NUREG-0960
Vol. 2

Draft
Site Characterization Analysis
of the Site Characterization
Report for the
Basalt Waste Isolation Project

Hanford, Washington Site

Appendices E through W

Figure L-3 Known and inferred structural trends, based on aeromagnetic data (Source: SCR Figure 3-92, page 3.7.29)

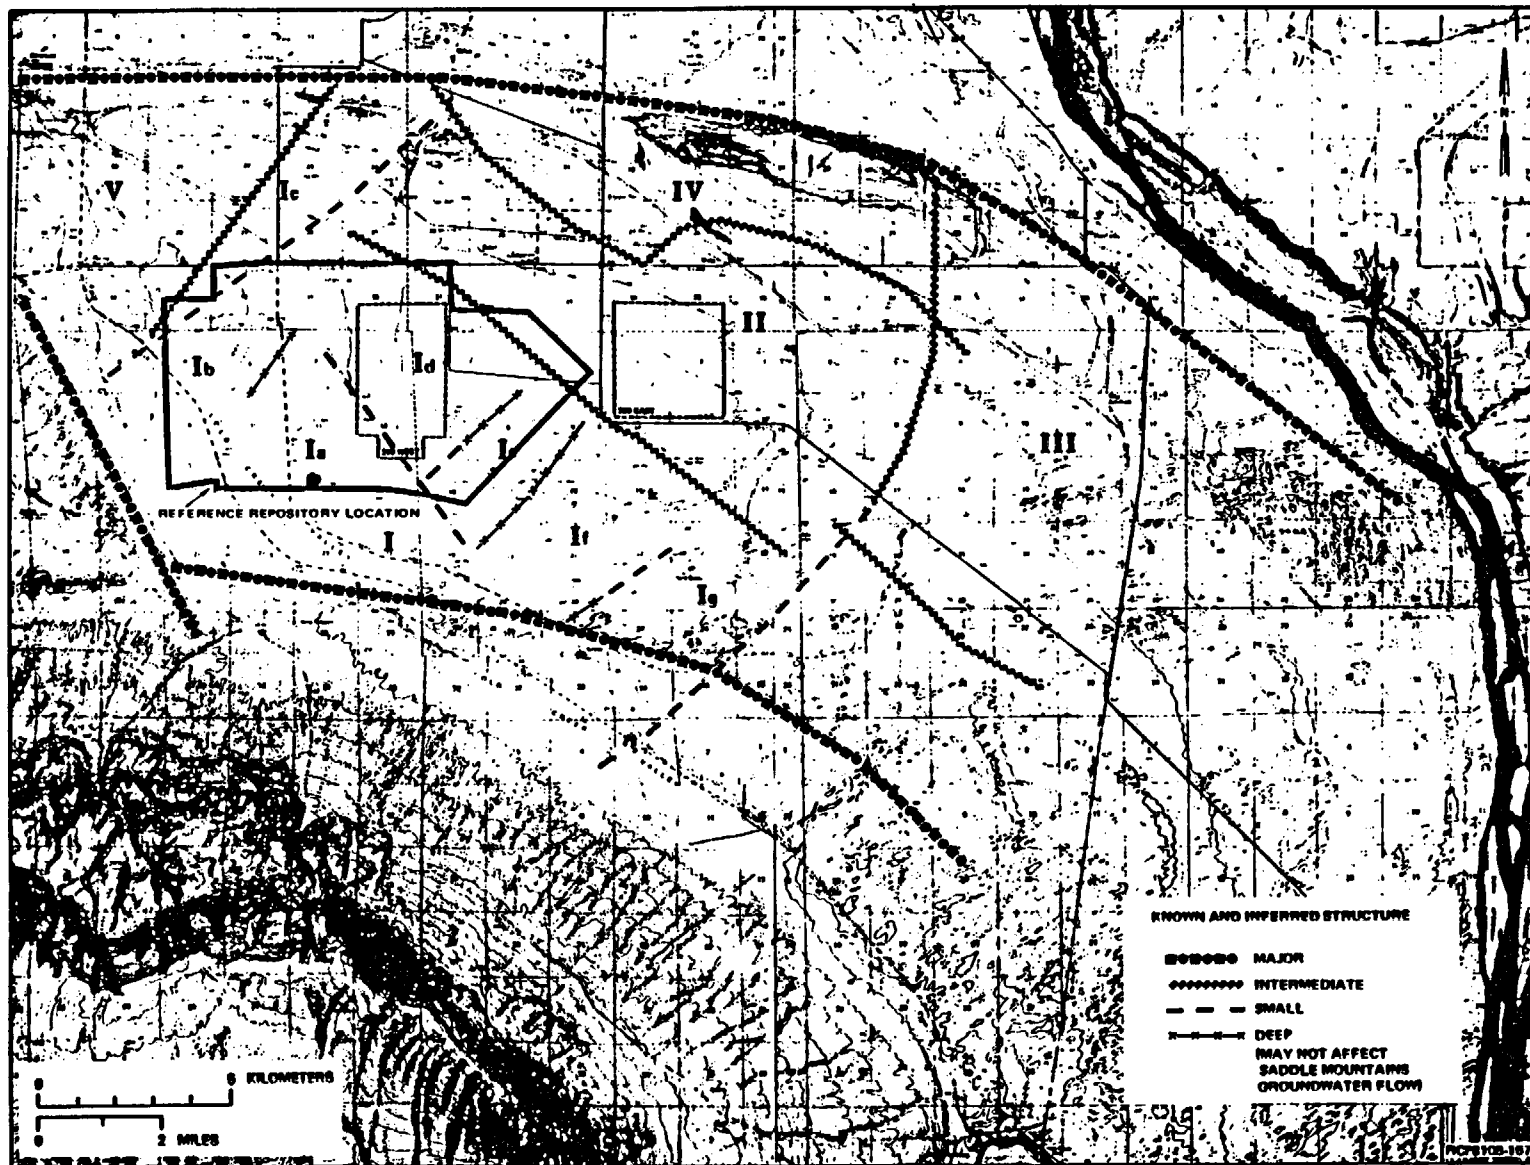
Other than the plans to test the Cold Creek Valley structure, no plans are presented to analyze the existence and significance of the inferred structures in the RRL area (Figure 3-52); therefore, these discontinuities will not be hydrogeologically characterized. Drilling and testing near Gable Mountain may increase the knowledge of ground water flow near this major structure but will do little toward defining the existence and effects of structures on a large scale because multiple-hole, state-of-the-art, pump tests apparently have not been planned in this area.

- (3) An areally discontinuous, layered system bounded by high permeability structures. In this conceptual model, the layered basalt system is divided into a series of discrete blocks as suggested by SCR Figure 3-52 (page 3.7-29). The blocks are bounded by vertically disruptive features of high permeability (e.g., fault zones or tectonic breccias) which provide a direct means of recharge and discharge to and from deep aquifers. On the scale of the zone between the RRL and the accessible environment, this is noncontinuum model for which the porous-flow equivalent numerical modeling used in the SCR could yield erroneous and nonconservative flow paths, travel times, and radionuclide fluxes.
